COMBI bead breaker
MAXI bead breaker

NEW DESIGNS & INNOVATIONS

MODEL 10101 & 10102

REDESIGNED SEQUENCE VALVE - Adjustable and Longer Lasting...

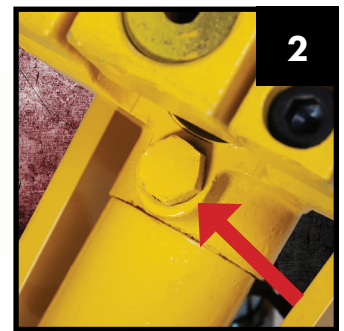
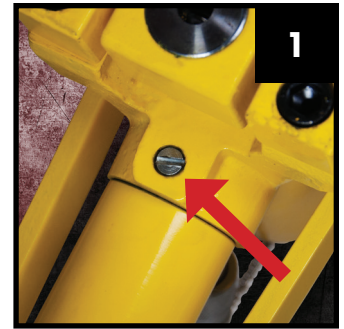
The "Sequence Valve Screw" has been redesigned to better aid in both usability and eliminating potential issues while the product is in use on the Wheel Assembly (1).

- ▶ **PROBLEM:** The Old Design Nut (2) would get damaged during the use of the tool. This damage would then make it difficult to service the bead breaker and/or adjust the sequencing of the bead breaker, eventually putting the bead breaker "out of service".

In addition to damaging the sequence screw over time, the spring inside of the bead breaker loses strength and clamping force weakens, resulting in the need to replace the spring or "shim" the spring with a washer, which is NOT recommended. This may also result in leaking of the valve body.

- ▶ **SOLUTION:** ESCO has redesigned the Sequence Valve Screw to a recessed adjustable set screw (1) that not only keeps the screw completely out of the way during the use of the tool but, also makes it a much more convenient solution for "adjusting" the sequence of the bead breaker while out in the field*.

*NOTE: It is possible to OVER TORQUE the Set Screw. This will result in damaging the tool or even the wheel assembly. Mark where you started with the set screw and adjust in "quarter turns" ONLY.

LOCK JAW PIN "SET SCREW" - More Control & Better Bites

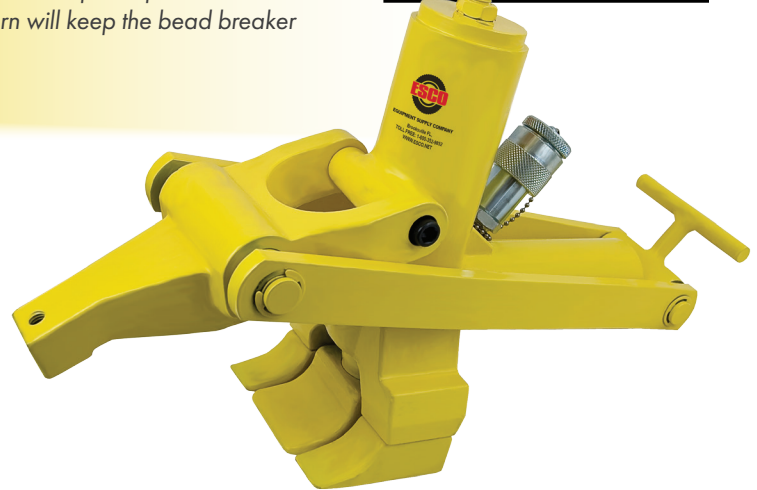
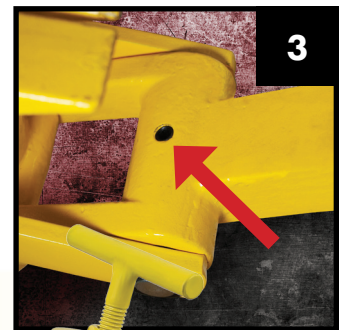
ESCO has redesigned the "JAW" to create a much stronger and stabilized gripping of tool onto wheel assembly (3).

- ▶ **PROBLEM:** The jaw of the bead breaker, due to its design, has some "give" allowing for it to move from side to side. This then will cause the bead breaker to grab onto the wheel assembly at an angle, causing potential scarring of the internal rams that operate the bead breaker.
- ▶ **SOLUTION:** ESCO has added an additional "set screw" (3) that clamps the jaw onto the pin centrally so that there is no movement on the jaw. This in turn will keep the bead breaker aligned straight, aiding in removing a potential for damage to the unit, giving a more precise grasp onto the wheel assembly.
